**CONDITIONAL APPROVAL**  
**PLAN APPROVAL EXPIRES: 05/10/2018**

Birch Creek Music Performance Center  
3821 Hwy E  
Town of Egg Harbor, 54209  
Door County  
NW1/4, NE1/4, S28, T30N, R27E

Revision; Plan Type: Addition-Alteration; 1 Interior Fixture(s)

Object Type: Commercial Water Treatment Device Regulated Object ID No.: 1588597  
Revision

**SHEET**  
P5

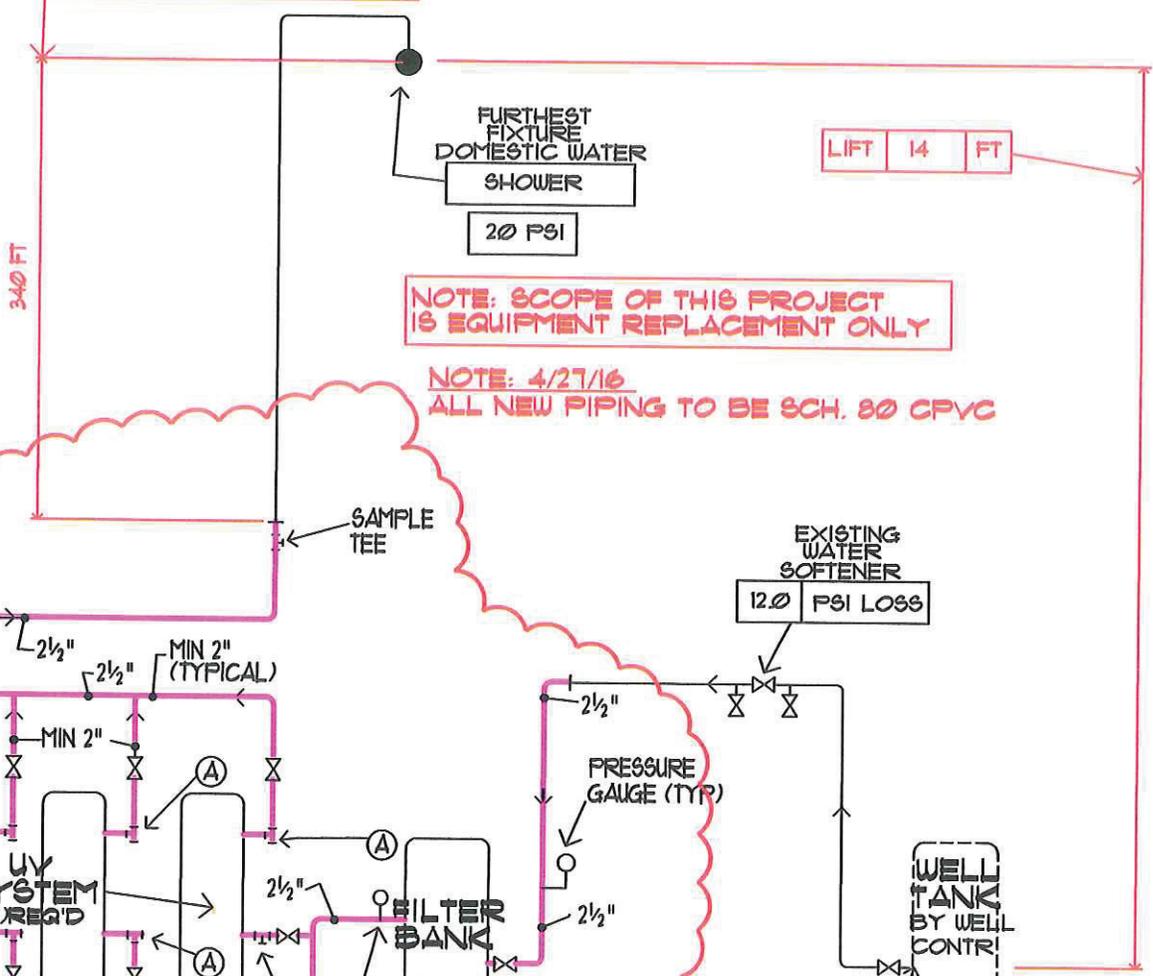
- **This plan approval replaces and supersedes the plan approved under transaction ID 2673867. There are two primary changes:**
  1. **An additional UV device has been added for a total of four; and**
  2. **Copper water distribution piping is being replaced with CPVC piping.**

- This installation consists of replacing existing UV devices and prefilters with new ones. The UV devices to be installed are four (4) Viqua UVMAX PRO30 models. The UV devices shall be installed in parallel. Each of the new UV units shall have:

1. A narrow band UV intensity monitor.
  2. Manufacturer supplied solenoid valves
  3. No bypass piping. If bypass piping is strongly desired, then the bypass shall be of the locking type.

- Each individual UV device shall be fitted with a flow control that prevents flow rates > 30 gpm.
- An owner's manual, installation and maintenance instructions shall be provided to the system owner and remain onsite.

NOTE: 4/27/16  
ALL NEW PIPING TO BE SCH. 80 CPVC
